SPARE PARTS LIST

CHAIN SAWS

556

Illustrated Parts List - IPL Update

B 556
CLUTCH & OIL PUMP

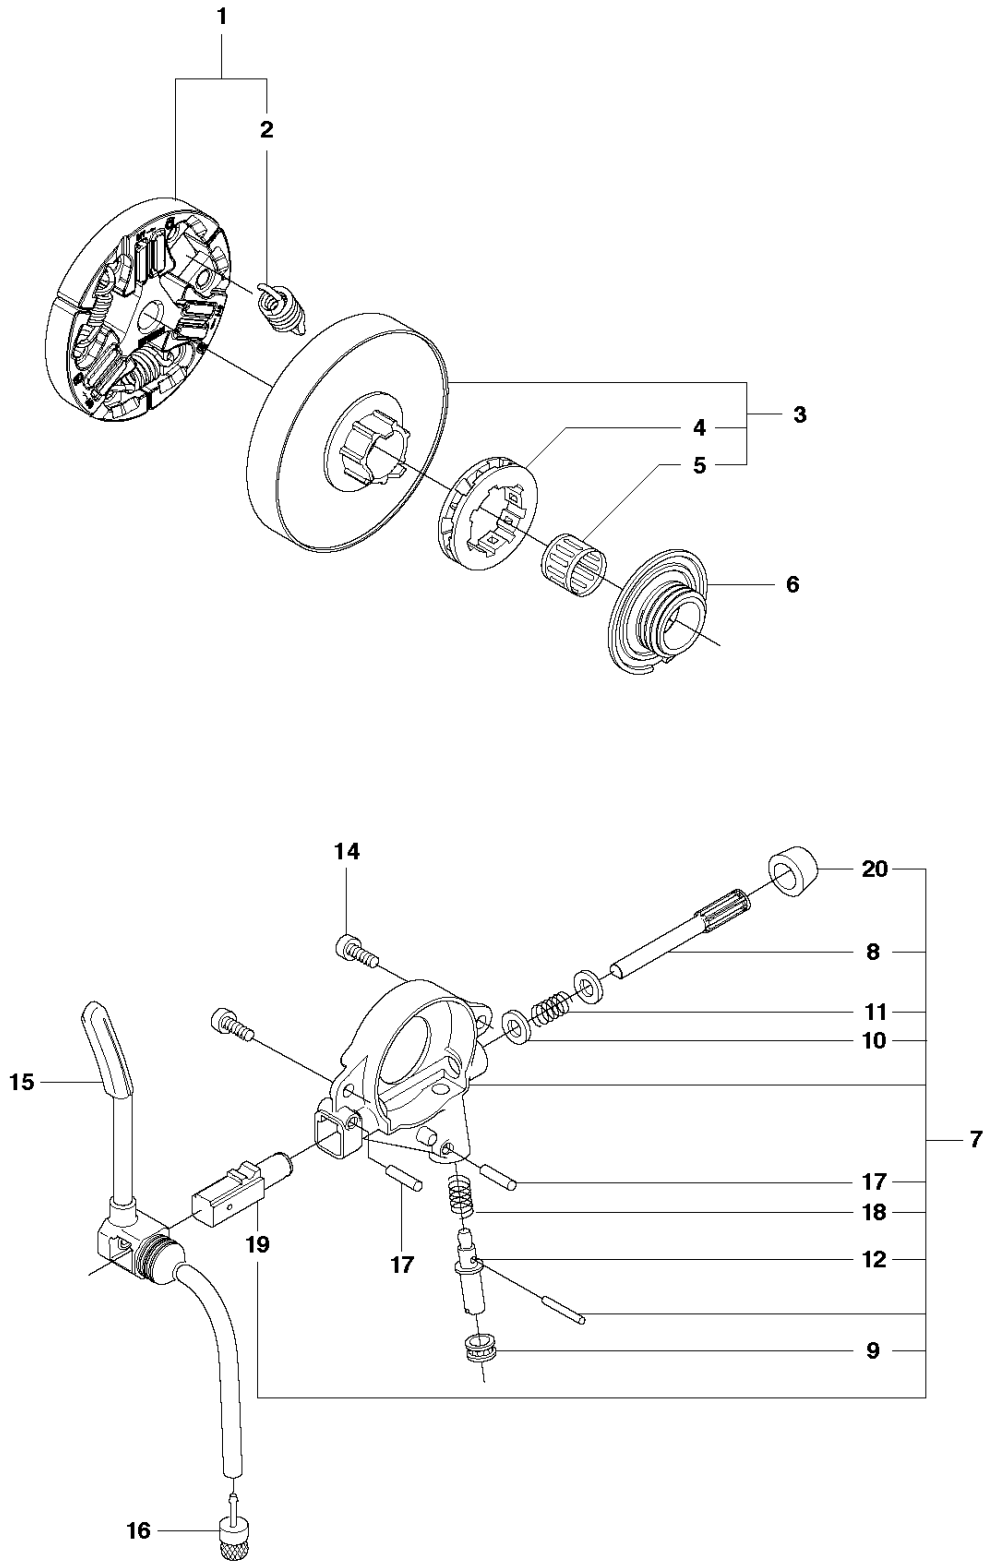
The Old spring 580 65 35-02 **can't** be used on the New Clutch 589 80 90-01. The New spring 502 16 47-01 **can't** be used on the Old Clutch 574 23 61-04.
6. A New Air filter, 505 12 63-07 has been introduced. This air filter has a new filter fabric with 25 µm. The new filter has an orange color.
The filter has not replaced any filter on PNC:s 556. 44 µm filter remains as spare part.

E 556
CRANKSHAFT

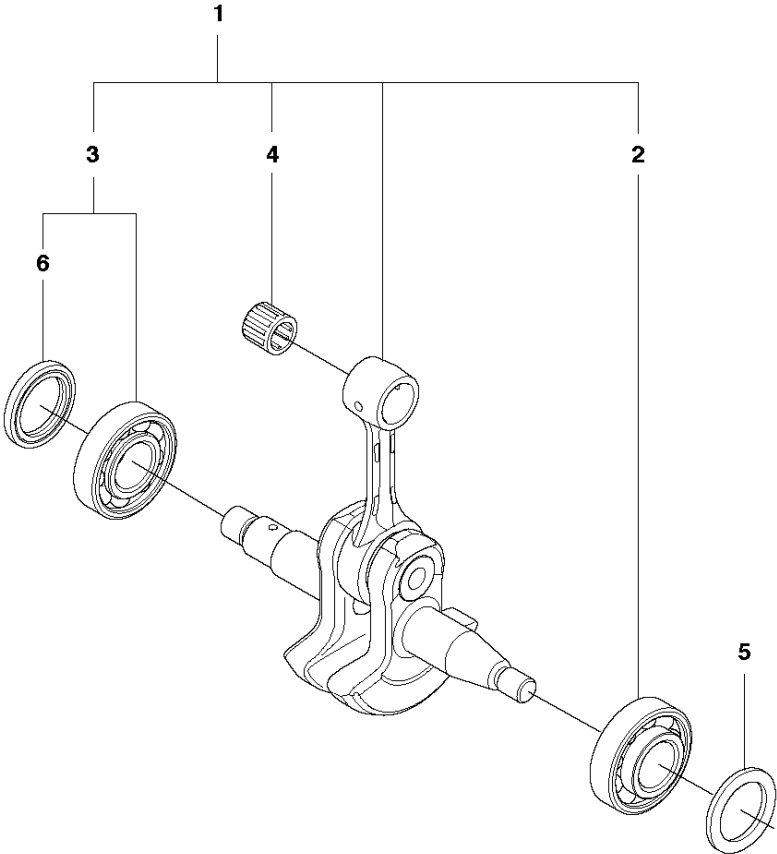
1. New Crankshaft 575 54 52-16 with new ball bearings. New ball bearings with improved durability.
2. New Ball bearings 525 43 42-03 and 505 13 35-03 with improved durability.
3. New Crankcase, assy 575 38 02-20 with new ball bearings. The Clutch side of the crankcase is made of Aluminium, which will increase the durability.
4. New Screw 510 02 06-02 for oil pump. This screw has a Micro coating, Dri Loc added for sealing. This due to the screw holes for the oil pump goes straight through the new crankcase.
5. A New Clutch, assy kit 589 80 90-01 with increased lifetime has been introduced. This kit consists of Clutch, assy and an instruction.

Serial number / Date	Remark
s/n 20162400208	Valid for Bearings and Crankshaft.
s/n 20164300001	Valid for Crankcase assy. and Screw IHSCM.
s/n 20164100193	Valid for Clutch assy.

5. Clutch kit.
New version.

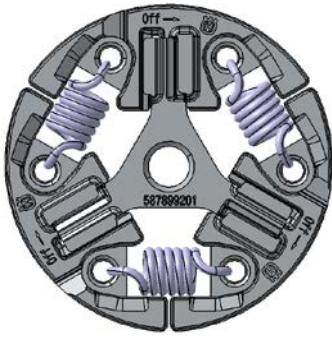
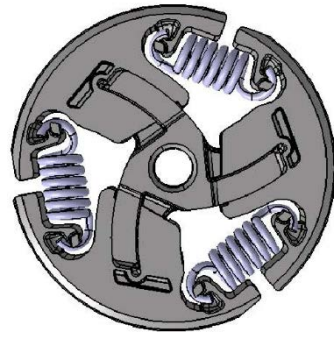
This update is fully exchangeable except for the Clutch spring. The Old spring 580 65 35-02 **can't** be used on the New Clutch 589 80 90-01 and The New spring 502 16 47-01 **can't** be used on the Old Clutch 574 23 61-04.
